# Submission to the Light Rail Stage 2B Draft Environmental Impact Statement

**SUBMISSION TO THE LIGHT RAIL STAGE 2B  
DRAFT ENVIRONMENTAL IMPACT STATEMENT**

PUBLIC TRANSPORT ASSOCIATION OF CANBERRA

**Figure 3:** Removing slip lanes provides a safer environment for pedestrians and additional room for landscaping and other amenities.

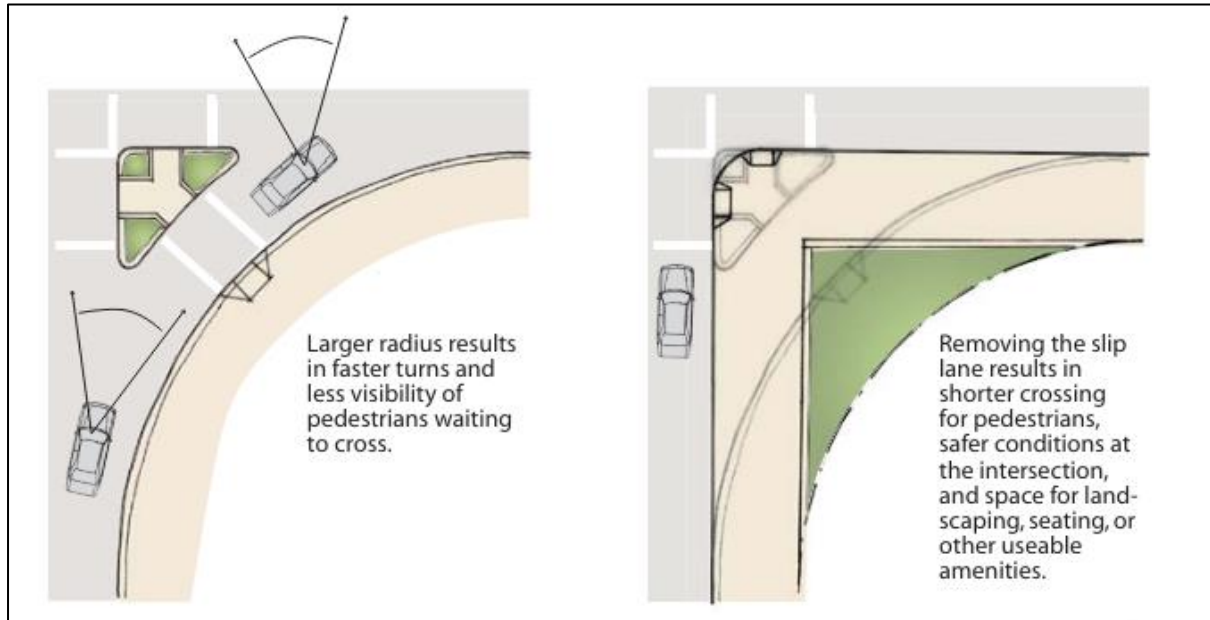
- PTCBR urge the redesign of roads surrounding this station to allow for comfortable and safe pedestrian access from all directions. This should

involve the removal of all slip lanes at this intersection (as described in [Figure 3](#)), as well as:

- timely pedestrian access to the light rail station - no lengthy waits at traffic lights
- appropriate levels of pedestrian storage capacity - no crowds forced onto small islands, and
- safe, unambiguous, formal crossing points.
